AGENDA

Village of Arlington Heights

July 16, 2018

- A. Hickory/Kensington - 4 N. Hickory Ave. - PC#18-005
Planned Unit Development, Preliminary Plat of Subdivision, Variations
- B. Christian Liberty Subdivision - 502 W. Euclid Ave. - PC#18-011
Preliminary & Final Plat of Subdivision, Variations

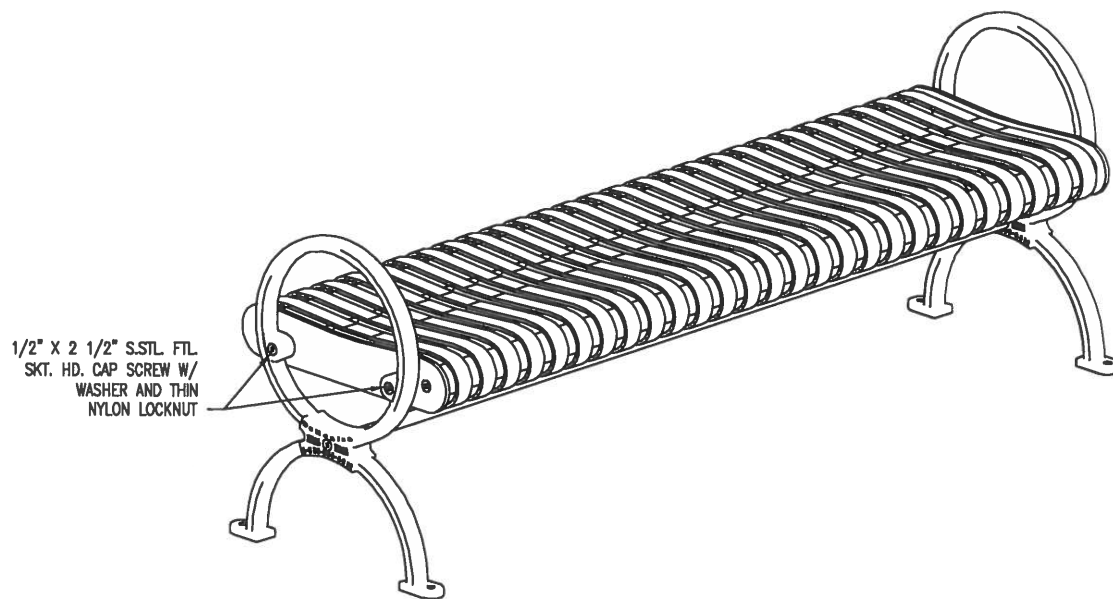
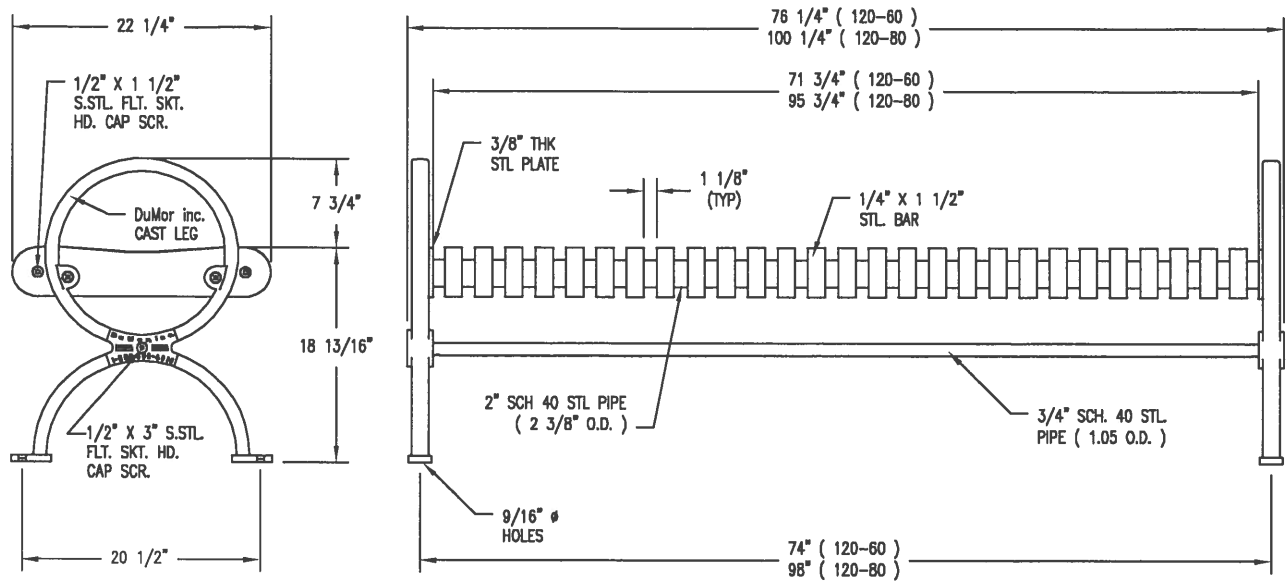
- 12) Along Kensington, it is recommended that large freestanding raised planters be incorporated at the base of the building to soften the large span of concrete and near the entrance off of Hickory.

Please incorporate 6 or 9 round planters with varying sizes (23" – 48" diameter). See attached sheet.
